**RE: Eqe Bay Exploration Program – Response to Reviewer Comments  
Type B Water Licence Application (2BE-EQE----**

Table 1 - Response to CIRNAC Comments on Type B Water Licence Application

Table 2 - Response to QIA Comments on Type B Water Licence Application

#### **Figure 1 – Proposed Exploration Area Layout**

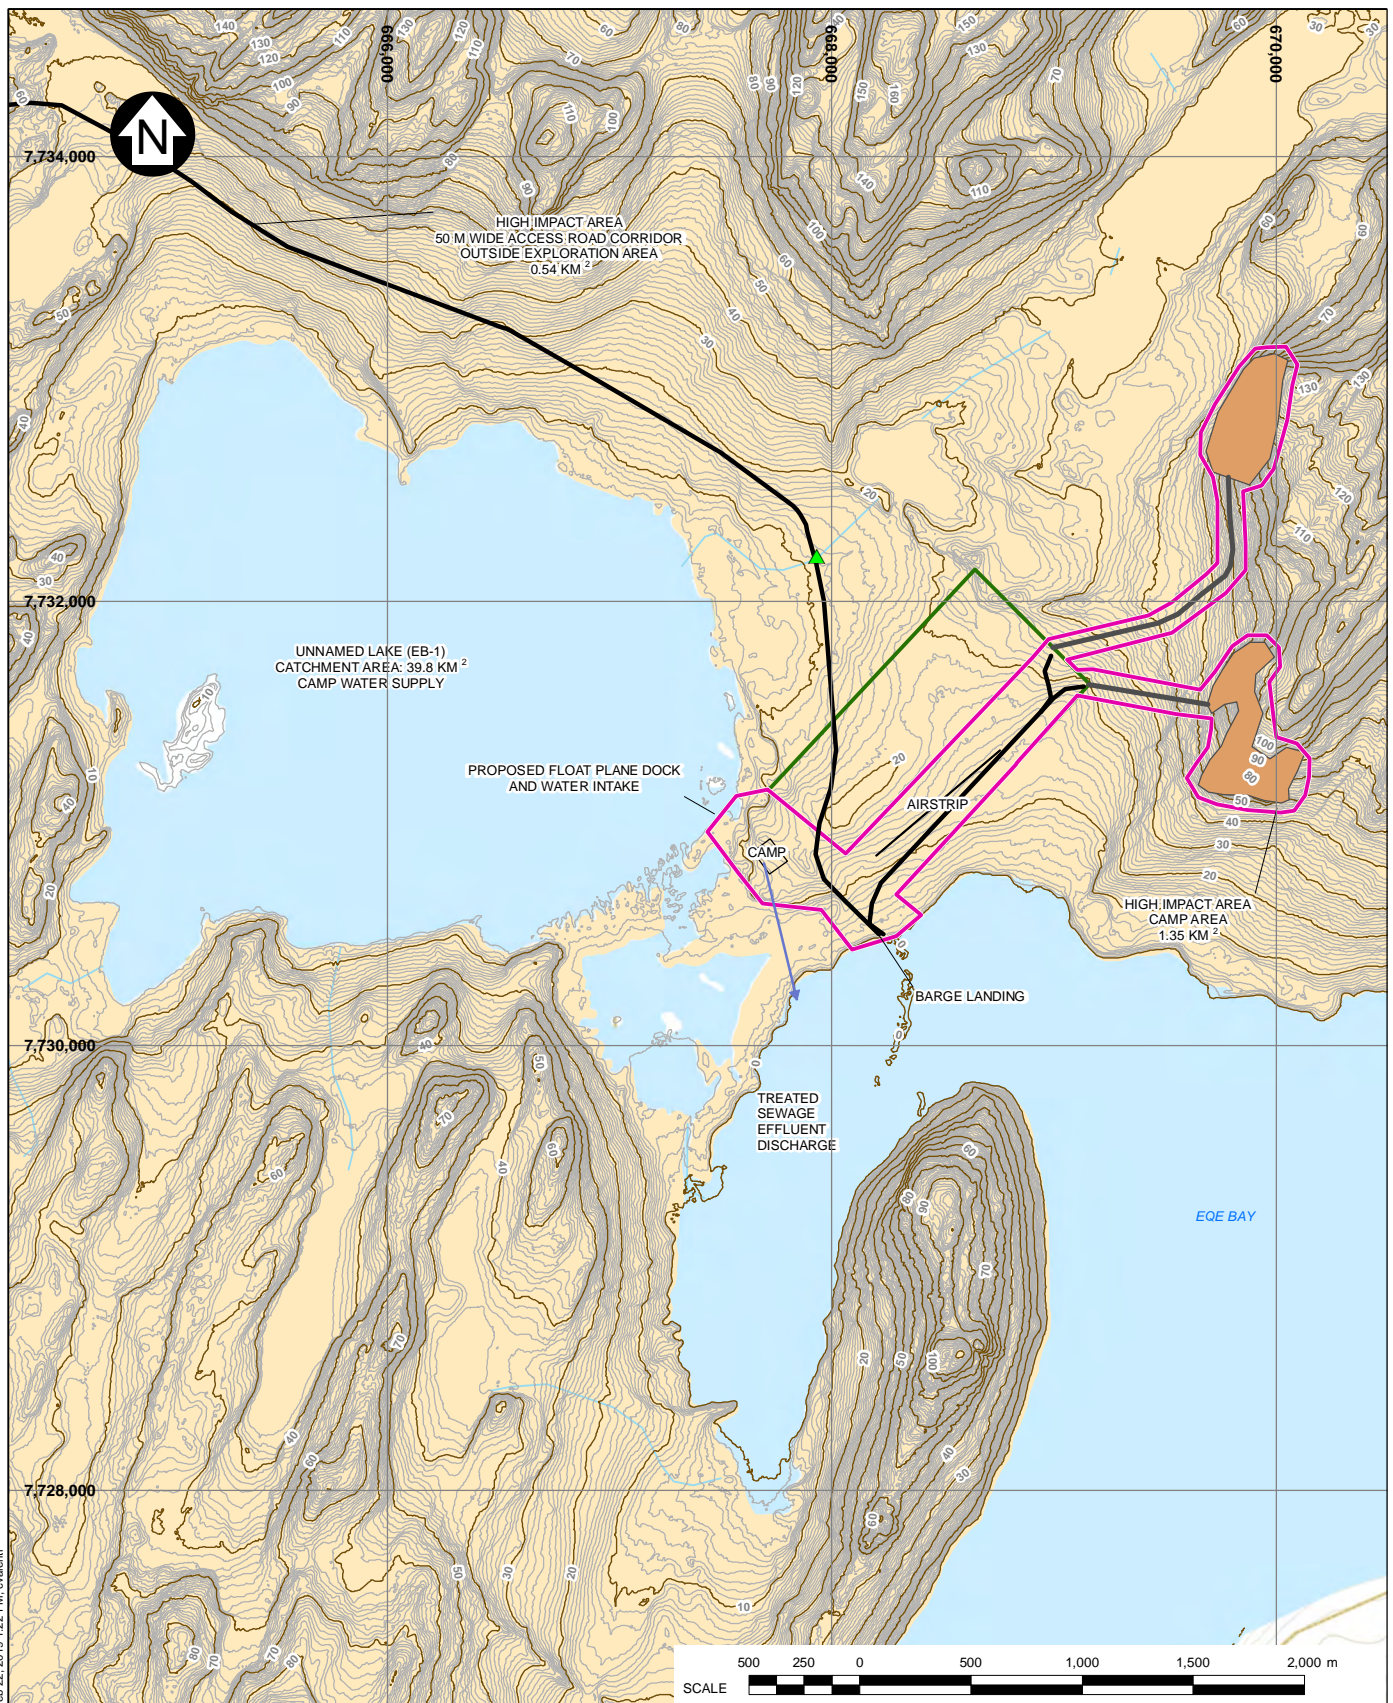
8	<p>At the Igloolik meeting on April 5, 2018 with the Mayor and Council, HTA Representatives and QIA Representatives, a comment was made to Baffinland that “this site is closer to the tide water; I imagine you’ll have measures to protect the marine environment?” CIRNAC Waters requests a map be provided to the NWB for interested parties to review of the high tide mark, including anticipated storm surge height, for the EQE Bay Exploration Program. Mitigative measures on how infrastructure will be protected from high tide water should be included in the revised management plans for review.</p>	<p>Baffinland understood the comment from Igloolik to mean that a future mining operation at Ege Bay, as a source of noise, dust, effluents, etc., would be in close proximity to the marine environment, and not that the exploration camp may be vulnerable to storm surges. The contour intervals shown on the site layout (Figure 3 in Attachment 7 - Project Proposal) are 20 m, and as such, it appears that the exploration camp area is close to sea level, but it is well above the high water mark and not at risk from storm surges. A close-up of the camp area with 1 m contours is shown on the attached Figure 1. The camp will be located at about 10-12 m above sea level.</p>
